Required Dealer Action

Table 5. Caliper Replacement Part Numbers

Figure 1. Recall Caliper Kits

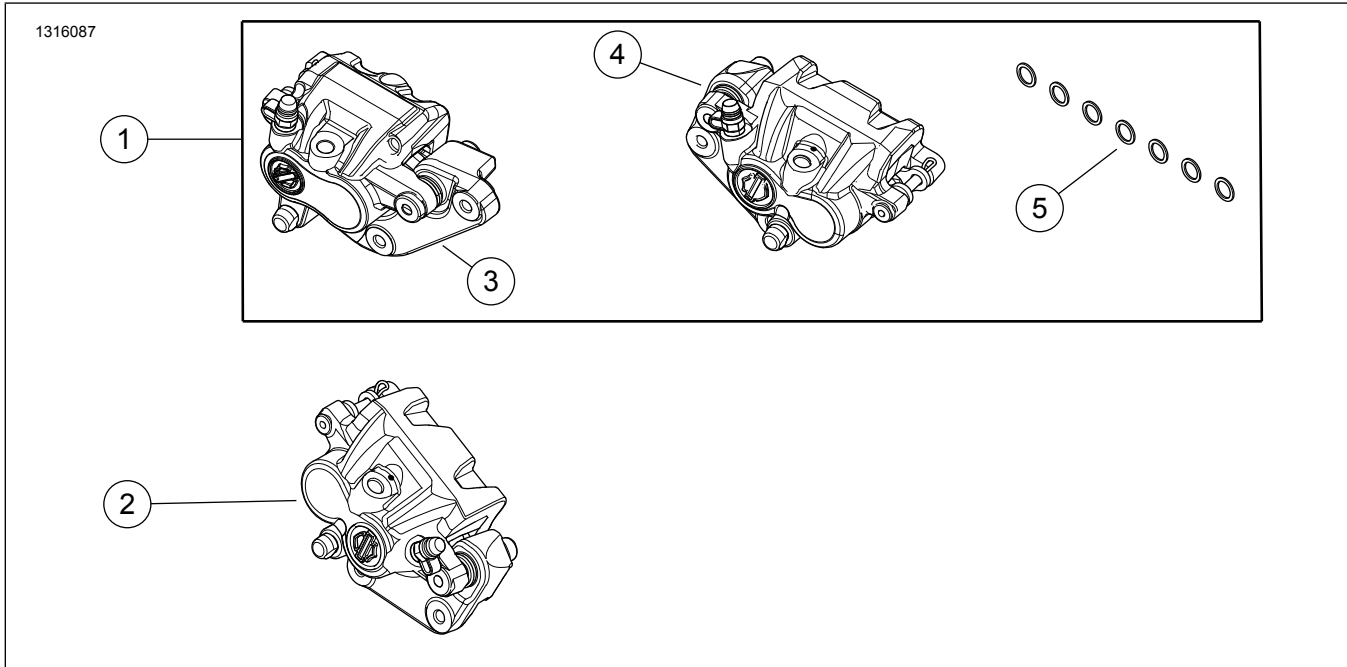
- a. Insert the vehicles VIN (Vehicle identification number), click SEARCH.
2. Replace the calipers by following the service manual for the year and model of the vehicle this bulletin is being applied to.

Models	Item	Kit	Kit Items	Qty	Description	Part No.
500, 750, 750A	1	91500097	3	1	Left front caliper	41300158A
			4	1	Rear caliper	41300159A
			5	7	Banjo washers ⁽¹⁾	12300033
750A ⁽²⁾	2	91500098	2	1	Right front caliper	41300190A

(1) Installing kit 91500097 uses four washers, installing kit 91500098 uses three washers. There will be three extra washers after installation of kit 91500097 only.

(2) Both kits 91500097 & 91500098 must be installed on 750A models.
